UNITED STATES PATENT AND TRADEMARK OFFICE

APPLICATION NO.	FILING DATE	FIRST NAMED INVENTOR	ATTORNEY DOCKET NO.	CONFIRMATION NO.
10/698,536	10/31/2003	Percy A. Dickens	2826502.000001	9964
44777	7590	10/06/2005	EXAMINER	
W. EDWARD RAMAGE COMMERCE CENTER SUITE 1000 211 COMMERCE ST NASHVILLE, TN 37201			CHIN, PAUL T	
			ART UNIT	PAPER NUMBER
			3652

Office Action Summary

Exhibit A

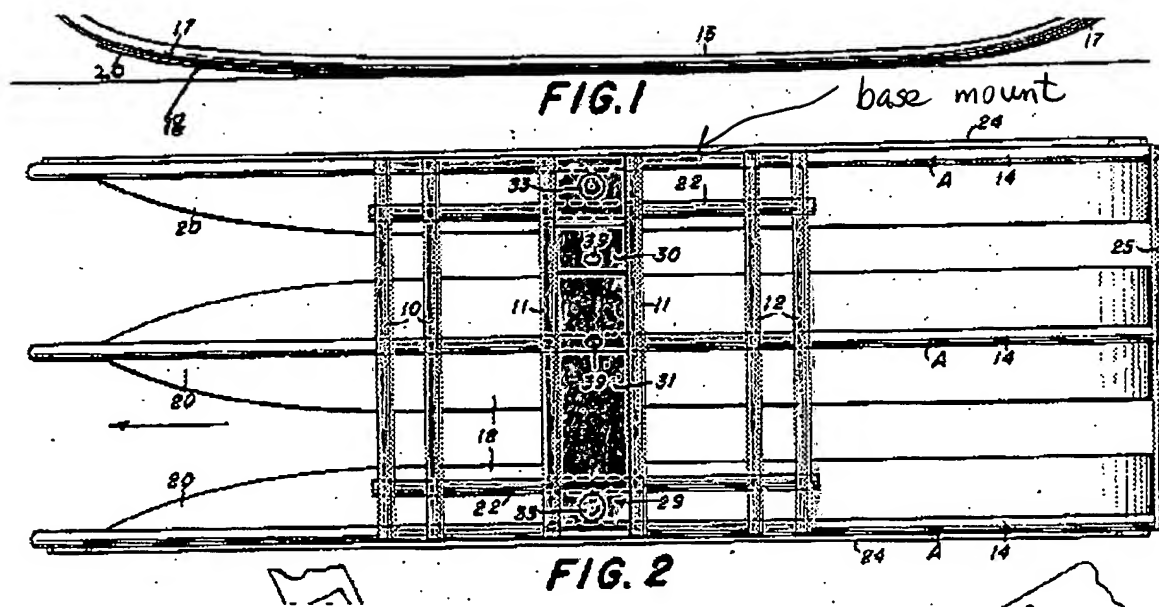
Griffith, Jr. (2,864,228) discloses a device for retrieving nuts comprising an elongated handle (36), a rectangular base mount (see exhibit A) affixed to on end of the handle, and a box shaped basket . Note that Exhibit A shows a rectangular shaped base mount and each substantially U-shaped rod being fixed to the first and second ends to the base mount wherein each rod is parallel to each other and the opposing ends are open.

Re claim 5, Exhibit A shows two rectangular pieces.
